BUILDING PERMIT

This is to certify that Wilson Samuel E III Va Vet & Family Co  
 has permission to Build new 3 season 8' x 16' sunn  
 AT 259 Spring St City of Portland  
 CE# 056 G032001

**City of Portland, Maine - Building or Use Permit Application**

Proposed Use: Single Family / Build new 3 season 8' x 16' sunroom.	Proposed Project Description: Build new 3 season 8' x 16' sunroom.
---	---

PROPOSAL

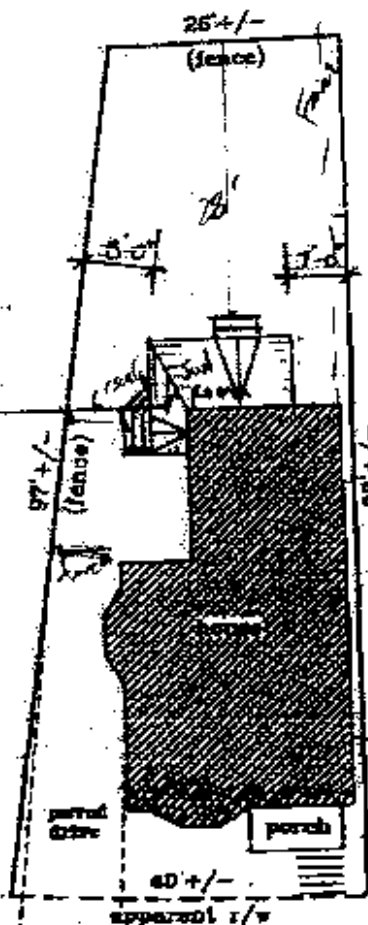
You would need to document **why the normal required setbacks** can not be met. I do not have the magic words for you. You need to convince me. If I see that you can in some way meet a greater setback, I would default to that.

14-433 is not "new" language. Those setbacks are not automatic. You need to meet all the requirements that are stated in that paragraph. You need to prove to me **that you can not meet the normal applicable yard dimensions.**

1. Review available material:
  - Historic Preservation Application.
  - Pictures of Property.
  - Foundation, Roof, and Framing Plan.
  - Site Plot.
  - Use of space with scaleable drawings at proposed 7- and 8-foot side yard setbacks.

6. We are not trying to build out to the maximum available, just use what is there now, to accommodate the intended function of the garden room.
7. A scaling back to the 10-foot side yard setback would limit primary back door egress to a 24-inch passage; and, a room of 7'9" x 10'9" dimensions. The space could not serve its intended purpose and the building permit application would be withdrawn. \$400

WEST ELEVATION PROPOSAL

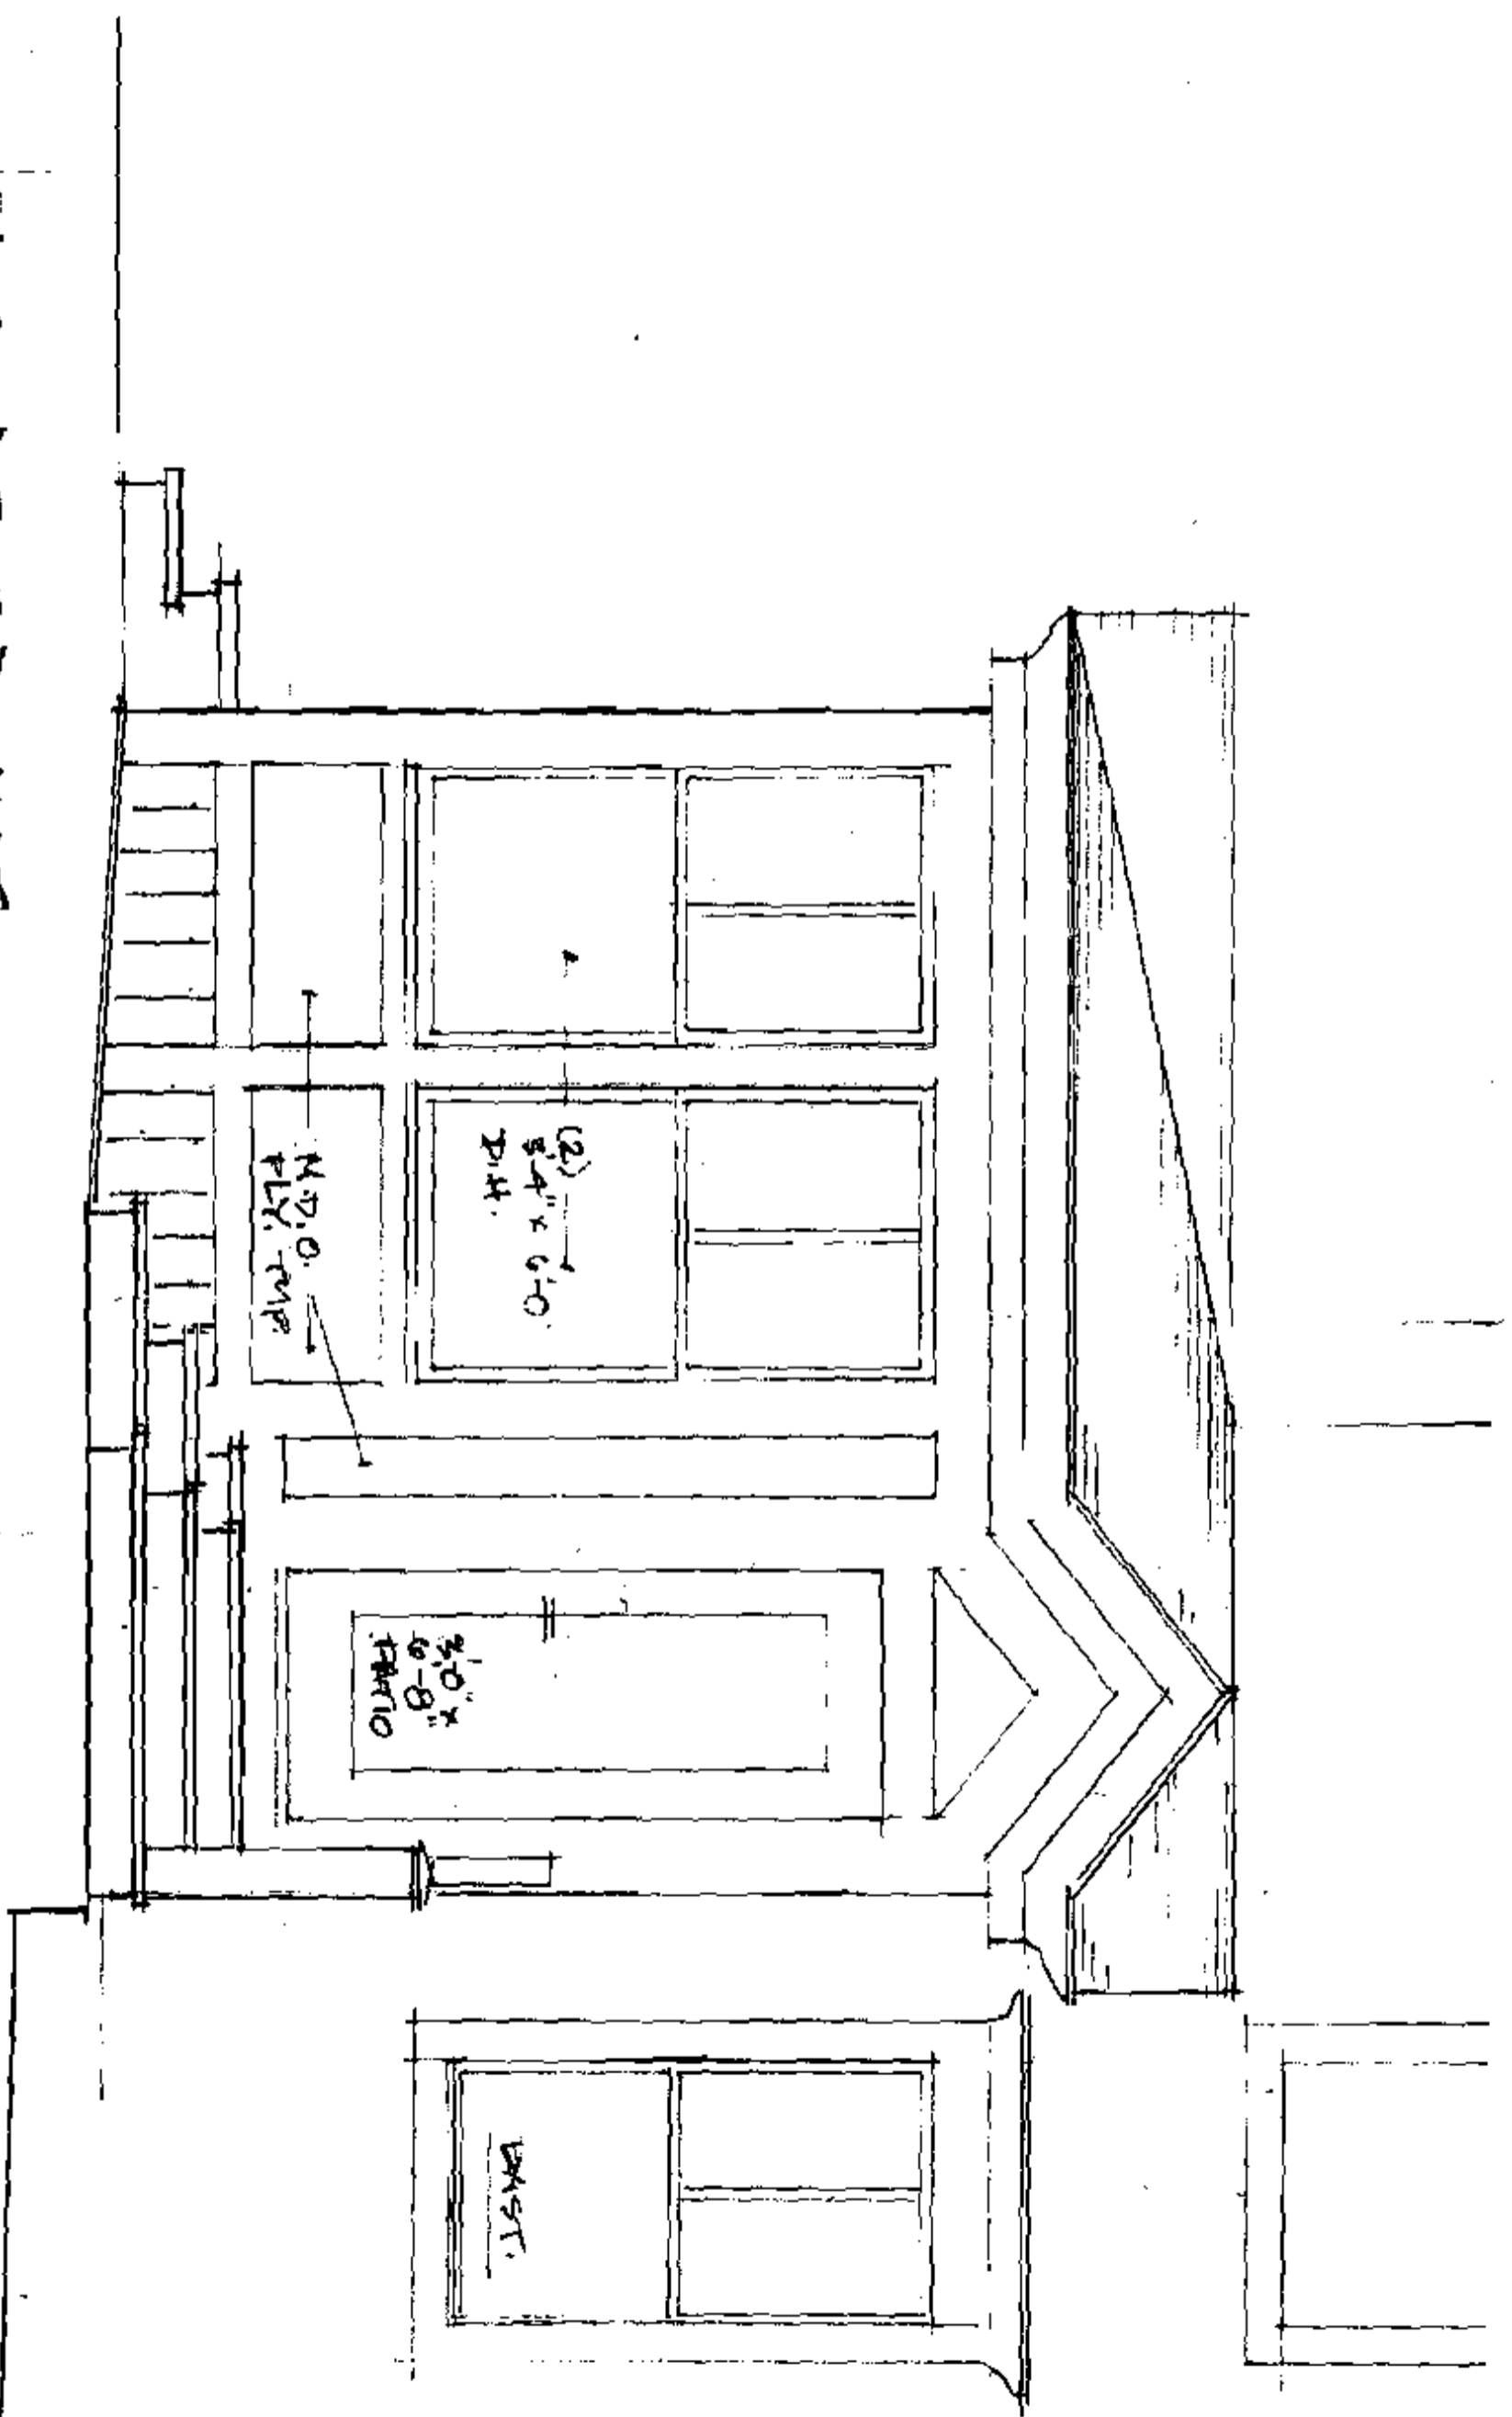
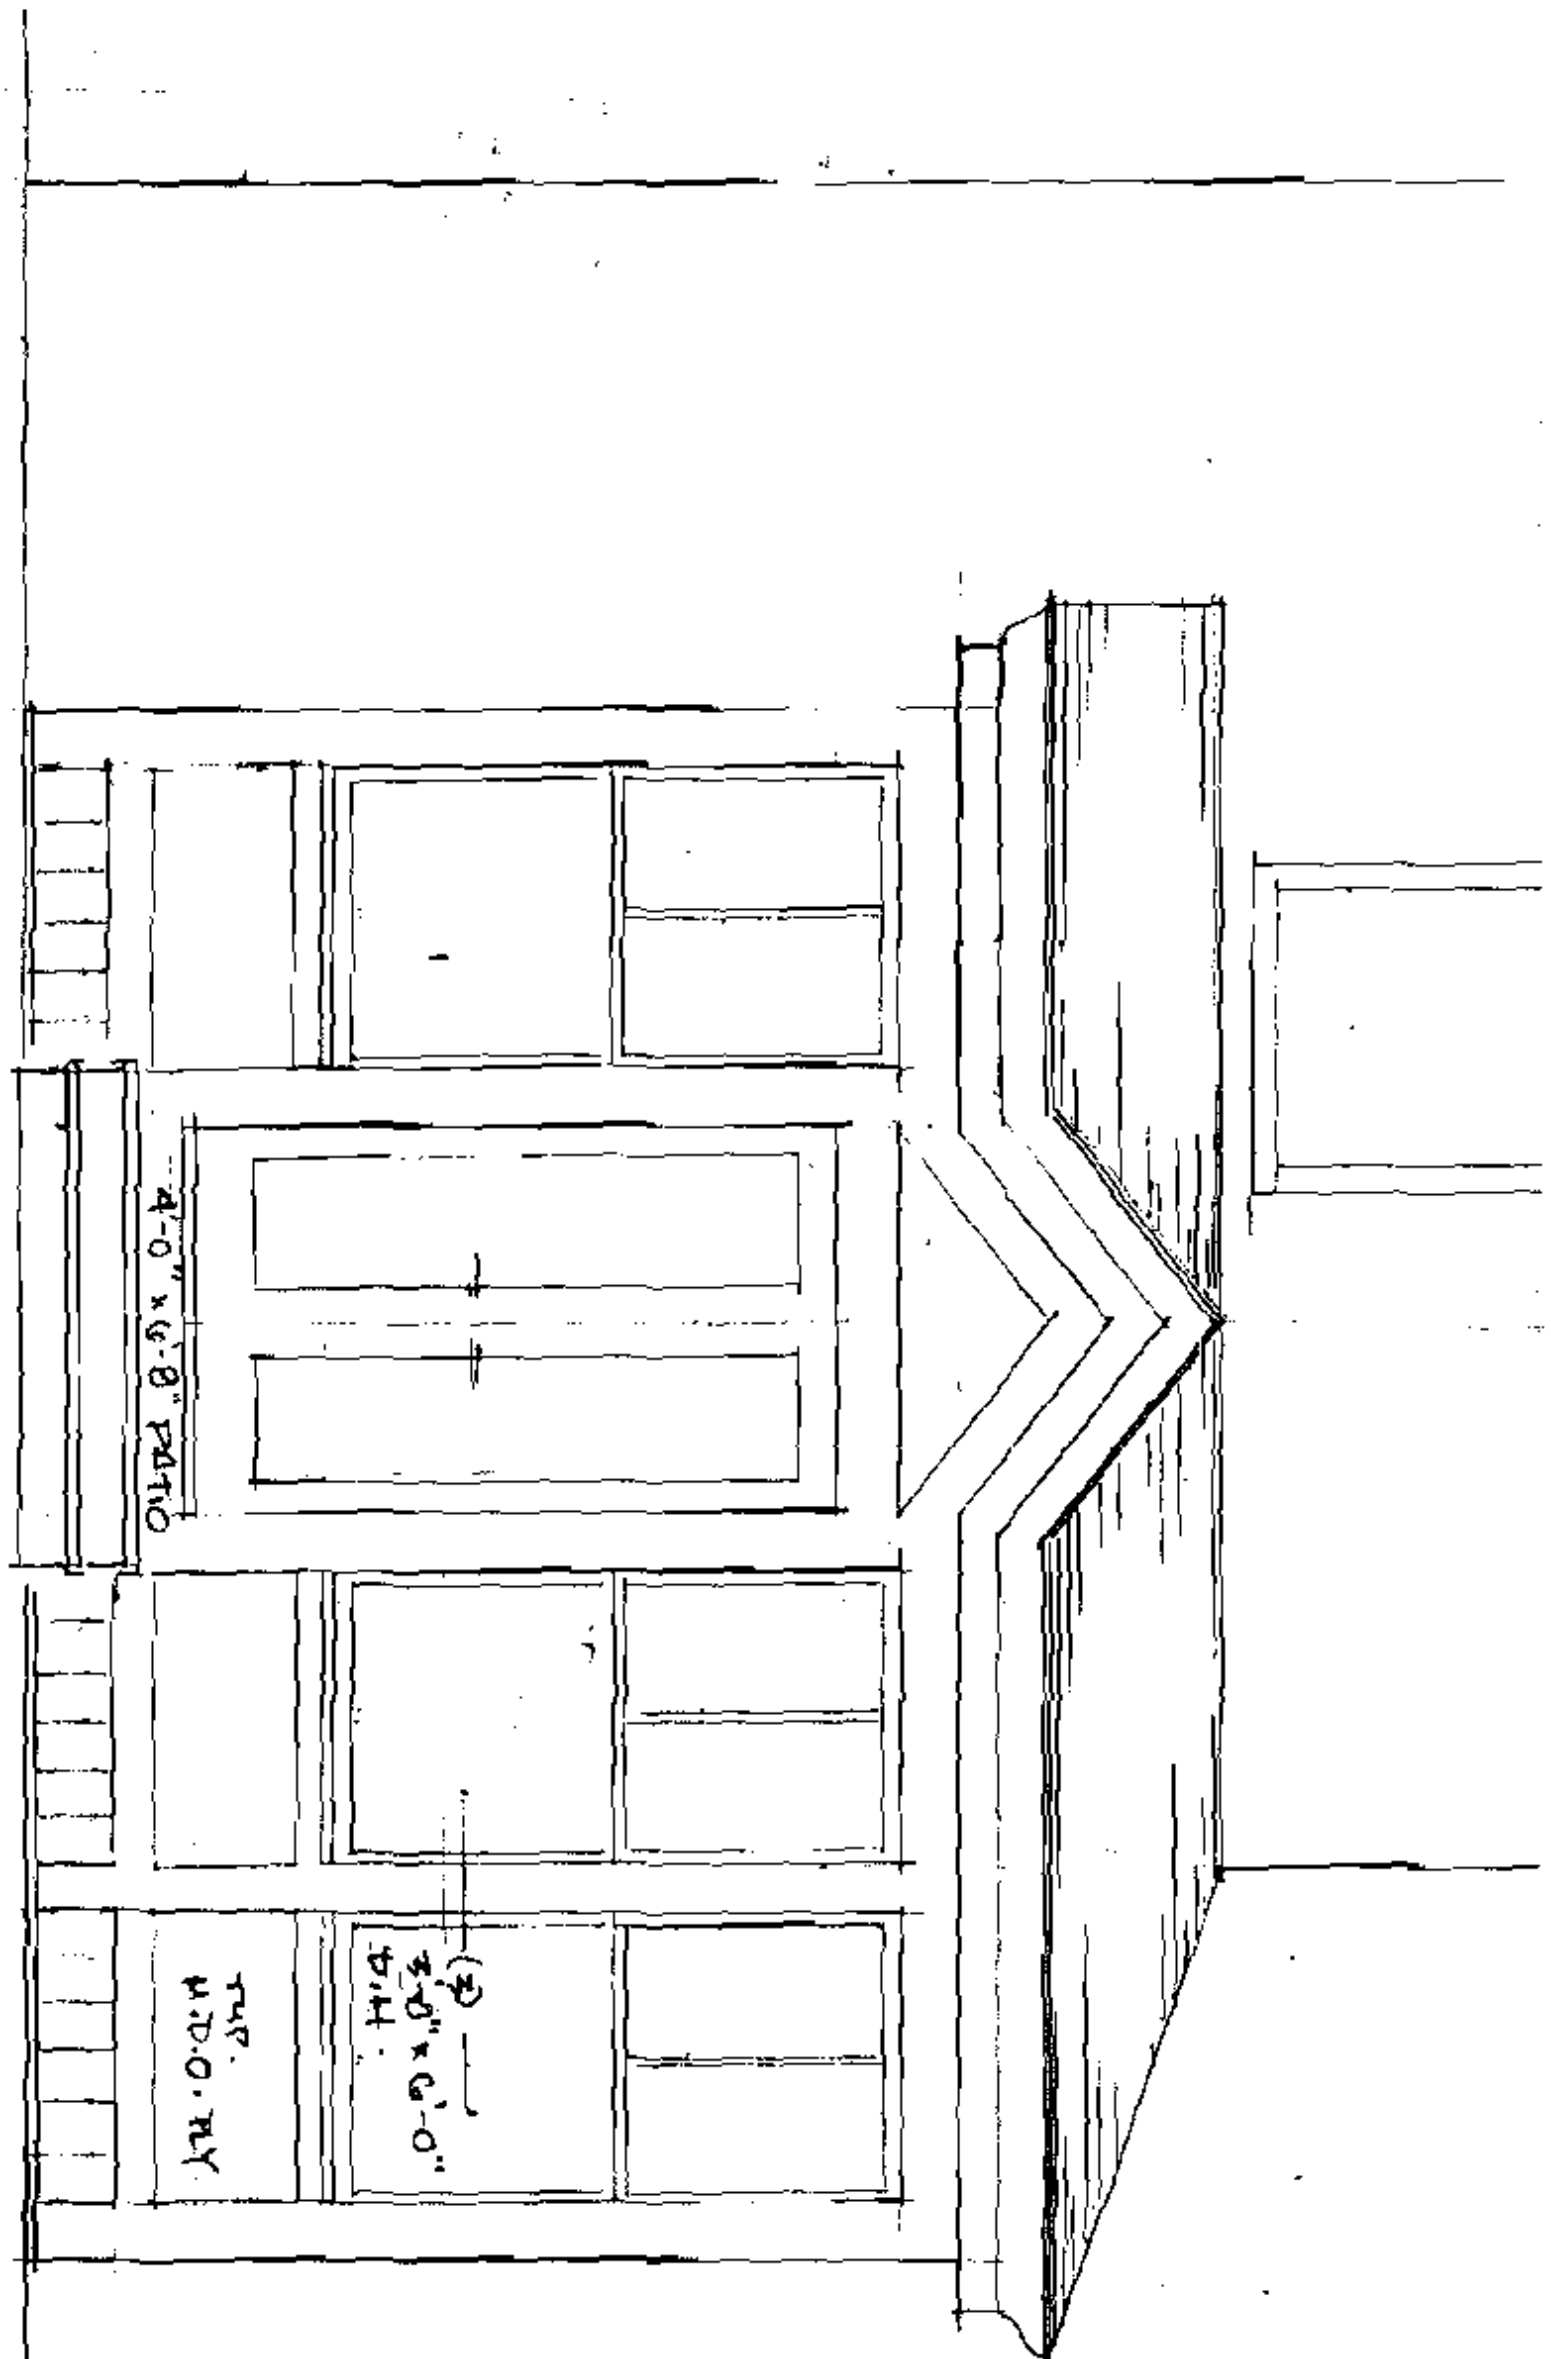
The measurement of the handrail is from the tread nosing (R311.5.6.1) to the top of rail, which I scale at around 27"-28". Since this is not dimensioned on the plan, you can confirm the 35", but be sure that this is reflected at the nosing, not the back of the tread.

The north side does not require a handrail, but the entry on the west side does as there are actually 4 risers to the floor level, IRC 2003 Sec. R311.5.6. If you continue to read, the height is a minimum of 34" and a maximum of 38" with the grip size as stated in R311.5.6.3(2). Hopefully Deb in historic will agree to these details.

It is easy to accomplish a 35" height for the handrail--I had measured from the second riser, and find that my drawing actually conforms from the first riser to the doorway trim.

For the entry steps on the west side, there are three risers @ 6" and treads @ 12". The post is 36" high, with railing at 31". Balusters will be 2 by 2's, spaced 3" apart. I have not discussed materials with the owners or contractor, but my suggestion is the post be p.t. construction with a built-up pitched cap, hand rail to be rectangular 2 by 4 stock to match that on the front of the house, finish on all to be painted, per Historic Review. My suggestion is that treads be synthetic pre-manufactured like Trex, with a wood grain pattern mounted up for best traction in the winter. They will not receive paint, but be chosen from existing colors like medium gray.
